City of San Antonio

Re: Lost Creek III (Amendment)

MDP # 828-B

LOST CREEK III MASTER DEVELOPMENT PLAN

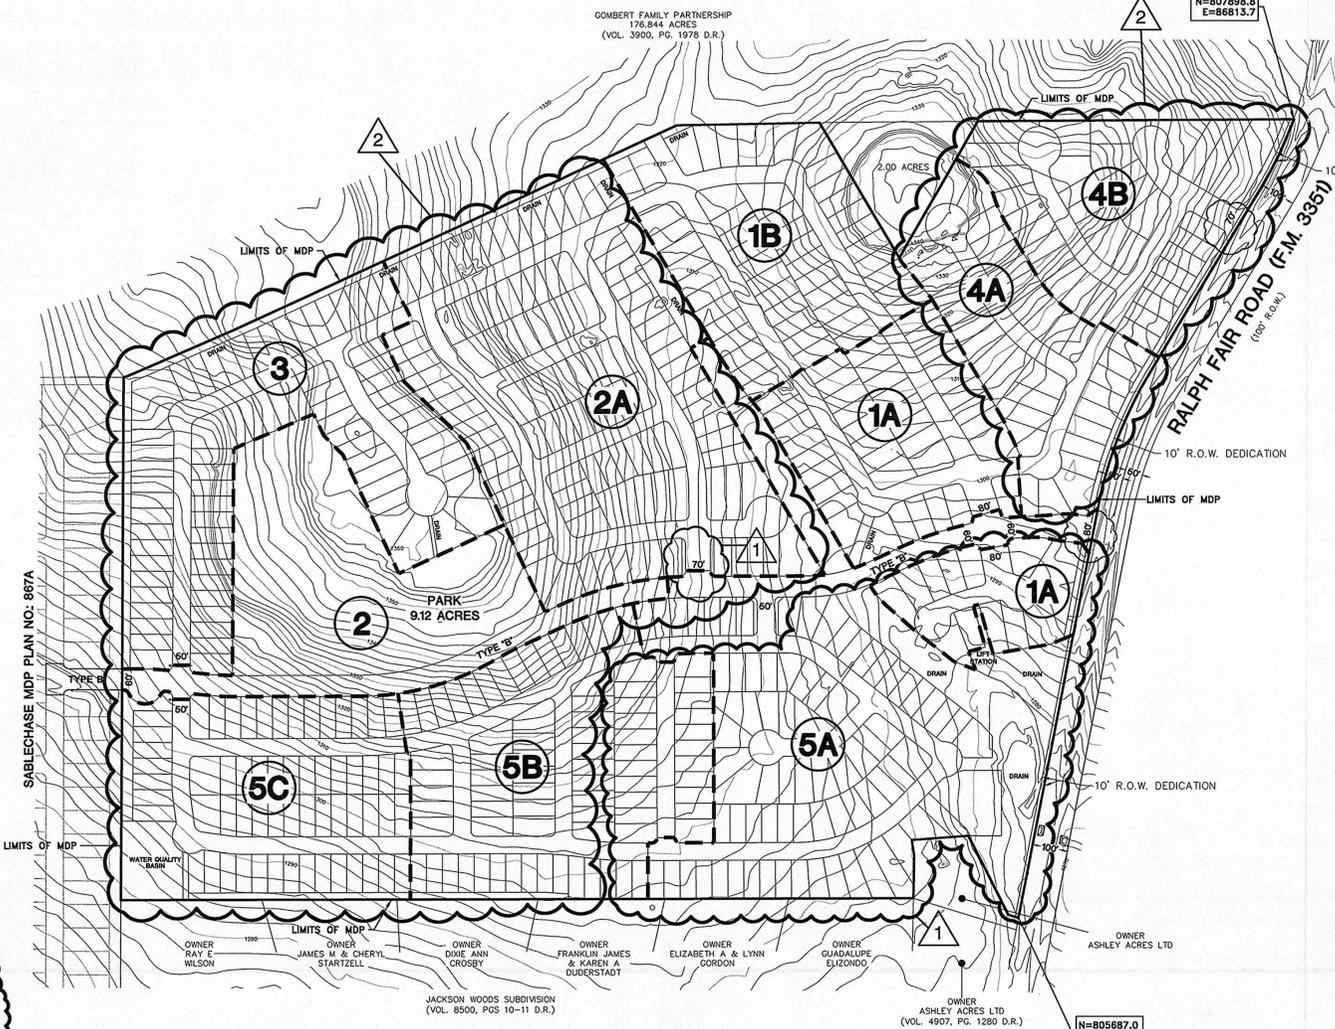
- Construct a northbound left turn-lane on Ralph Fair Road (FM 3351) at the proposed east/west Collector/Local B Street with a storage lane and bay taper as it relates to the submitted TIA traffic counts, (Unified Development Code (UDC) - 35-502 (a)(7), subsection C. (316 Peak left turn movements)

- The intersection at the proposed east/west Collector/Local B Street and Ralph Fair Road (FM 3351) will require mitigation in the form of a traffic signal (when warranted and approved by Bexar County Traffic, Public Works - Traffic and TX DOT) as per UDC 35-502, (a)(7)(C) Limitations on Traffic Impact Analysis. It is expected that the traffic signal shall be installed prior to, or concurrent with the last unit's construction (Unit-5).

- Unit-4 on the MDP indicates cul-de-sacs greater than 500-feet in length, requiring 120-foot diameter ROW, 100-foot diameter pavements and 30-foot pavement widths. UDC 35-506(d) (6) shall be complied with at the time of platting.

Parks and Recreation recommends approval with the following conditions: Lost Creek III is a proposed subdivision with 577 single-family residential units. UDC Section 35-503, Table 503-1 states that single-family development is required to provide 1 acre of park/open space per every 70 dwelling units. The requirement for this development is 8.2 acres. This subdivision provides 9.1 acres of park/open space dedication.

- Northbound left-turn lanes will be required on Ralph Fair Road at both entrances to the subdivision as per specifications and approval from the Texas Department of Transportation (TXDOT).
- Coordination with TXDOT is recommended for the funding of traffic signals on Ralph Fair Road adjacent to this development. Traffic controls shall be warranted as per the Texas Manual on Uniform Control Devices and approved by TXDOT.
- All grades and landscaping within the public right of way shall comply with the latest version of the TXDOT Roadside Design Manual.
